Accessibility Survey

Adwen Street & Old River School Road

Date of Inspection 4/11/2017

Disability Access Consultants

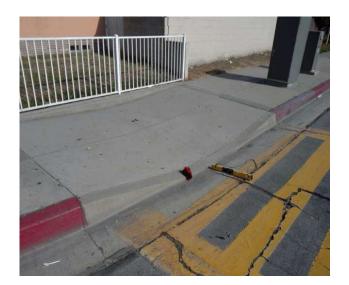
The transition from the bottom of the curb ramp to the walk, gutter, or street is abrupt.

On-Site Finding 0.75 inches

Patch the transition area at the bottom of the curb ramp so that the transition is flush and free of abrupt changes.

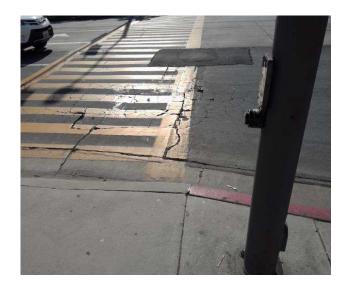
Push button distance from crosswalk is not compliant.

On-Site Finding 85.00 inches

Provide a compliant push button.

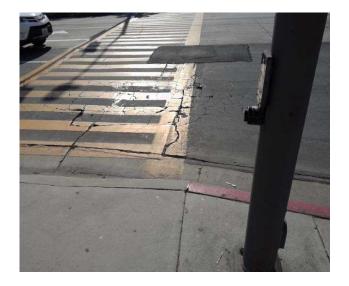
No locator tone provided for the pedestrian signal indicator.

On-Site Finding Not Found

Provide locator tone for the indicator.

Change In Level East Of Mitla Avenue @ 33.944322311452, -118.151902556419

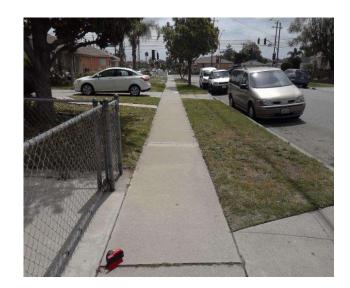
There is a change in elevation greater than recommended value.

On-Site Finding 0.50 inches

Ensure that the change in elevation is within the recommended value.

Change In Level East Of Mitla Avenue @ 33.944792920602, -118.152775615454

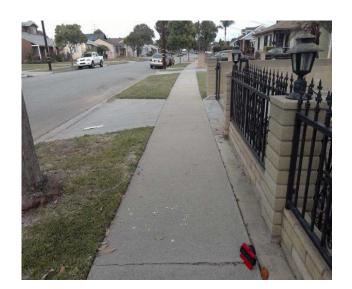
There is a change in elevation greater than recommended value.

On-Site Finding 0.50 inches

Ensure that the change in elevation is within the recommended value.

Change In Level East Of Mitla Avenue @ 33.945788645333, -118.154399693012

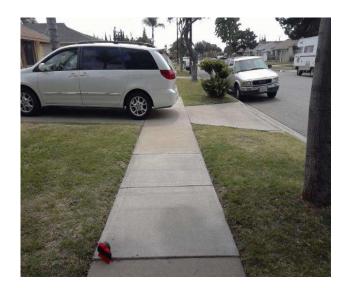
There is a change in elevation greater than recommended value.

On-Site Finding 0.62 inches

Ensure that the change in elevation is within the recommended value.

Change In Level East Of Mitla Avenue @ 33.945808670962, -118.154435902834

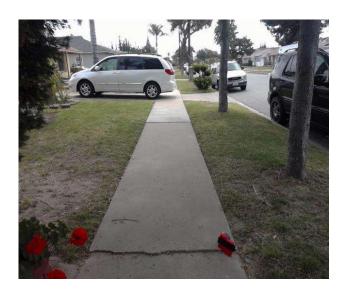
There is a change in elevation greater than recommended value.

On-Site Finding 0.62 inches

Ensure that the change in elevation is within the recommended value.

Change In Level West Of Old River School Road @ 33.944036384527, - 118.151712119579

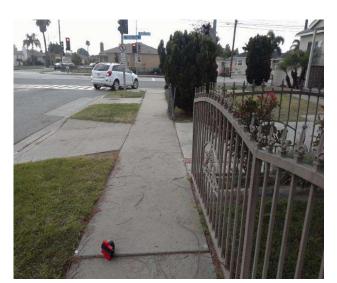
There is a change in elevation greater than recommended value.

On-Site Finding 0.62 inches

Ensure that the change in elevation is within the recommended value.

Change In Level West Of Old River School Road @ 33.944670540222, - 118.152881562710

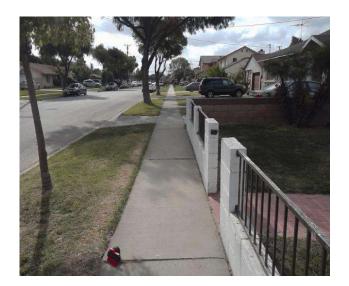
There is a change in elevation greater than recommended value.

On-Site Finding 0.62 inches

Ensure that the change in elevation is within the recommended value.

Change In Level West Of Old River School Road @ 33.945809783497, - 118.154769837856

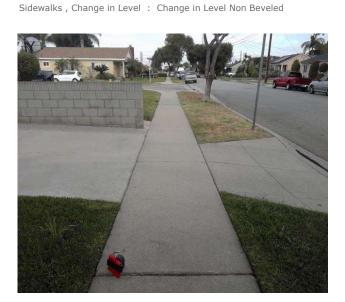
There is a change in elevation greater than recommended value.

On-Site Finding 0.75 inches

Ensure that the change in elevation is within the recommended value.

Change In Level West Of Ryerson Avenue @ 33.946342686006, -118.155777007341

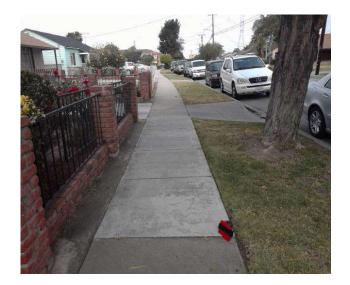
There is a change in elevation greater than recommended value.

On-Site Finding 0.50 inches

Ensure that the change in elevation is within the recommended value.

Change In Level West Of Old River School Road @ 33.945763057022, - 118.154675960541

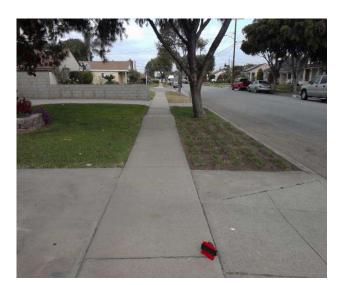
There is a change in elevation greater than recommended value.

On-Site Finding 0.37 inches

Ensure that the change in elevation is within the recommended value.

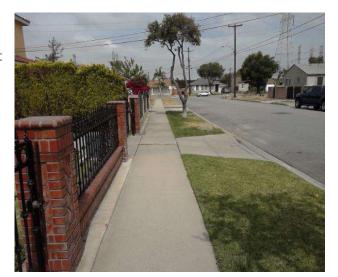
Sidewalk cross slope is not compliant.

On-Site Finding 3.80 percent for 181.00 feet

Repave the sidewalk surface with the recommended cross slope.

Change In Level East Of Old River School Road @ 33.942749145195, - 118.148657083511

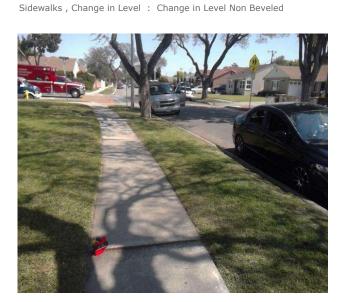
There is a change in elevation greater than recommended value.

On-Site Finding 1.50 inches

Ensure that the change in elevation is within the recommended value.

Change In Level East Of Old River School Road @ 33.942709092492, - 118.148583322763

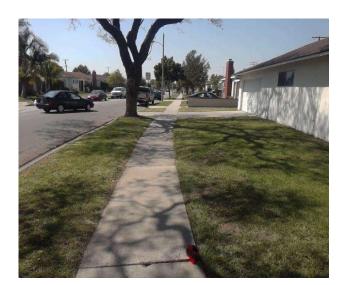
There is a change in elevation greater than recommended value.

On-Site Finding 1.12 inches

Ensure that the change in elevation is within the recommended value.

Change In Level East Of Old River School Road @ 33.943047314724, - 118.149208277464

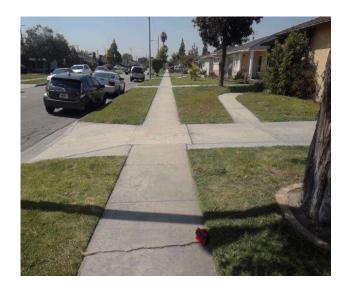
There is a change in elevation greater than recommended value.

On-Site Finding 0.50 inches

Ensure that the change in elevation is within the recommended value.

Change In Level West Of Rives Avenue @ 33.941230467022, -118.146102279425

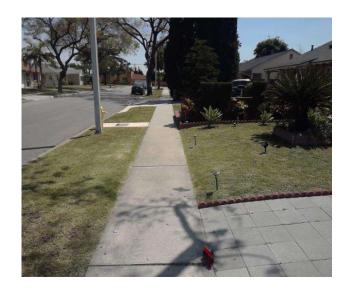
There is a change in elevation greater than recommended value.

On-Site Finding 0.75 inches

Ensure that the change in elevation is within the recommended value.

Change In Level West Of Rives Avenue @ 33.941643238642, -118.146854639053

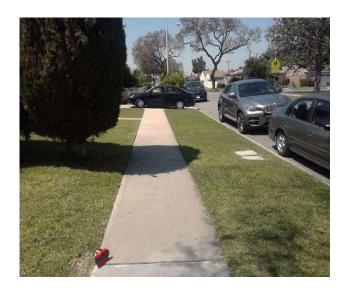
There is a change in elevation greater than recommended value.

On-Site Finding 0.50 inches

Ensure that the change in elevation is within the recommended value.

Change In Level East Of Old River School Road @ 33.942972772440, - 118.149075508118

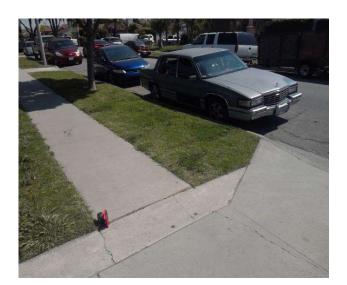
There is a change in elevation greater than recommended value.

On-Site Finding 0.37 inches

Ensure that the change in elevation is within the recommended value.

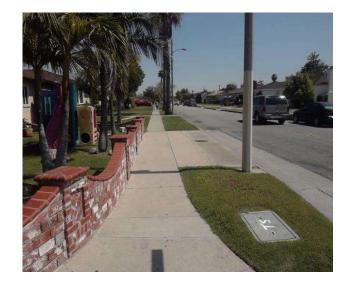
Turn area is not level.

On-Site Finding Not Level

Make sure that the turn area is level.

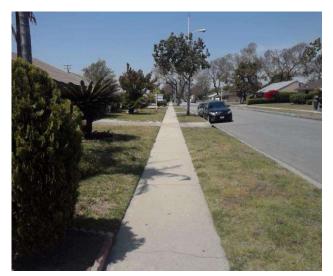
Sidewalk cross slope is not compliant.

On-Site Finding 4.00 percent for 269.00 feet

Repave the sidewalk surface with the recommended cross slope.

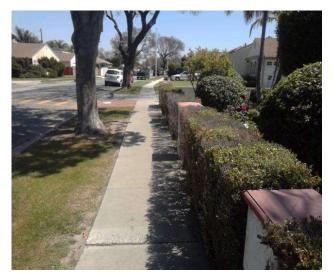
Ground surface has an opening that is not compliant.

On-Site Finding Not Compliant

Make sure that the surface opening does not allow passage of a sphere more than ½ inch in diameter.

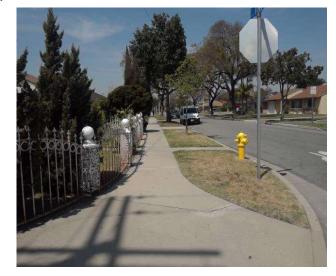
There is no 60X60 turn area at every 200 feet.

On-Site Finding Not Found

Provide a 60X60 turn every 200 feet on the sidewalk.
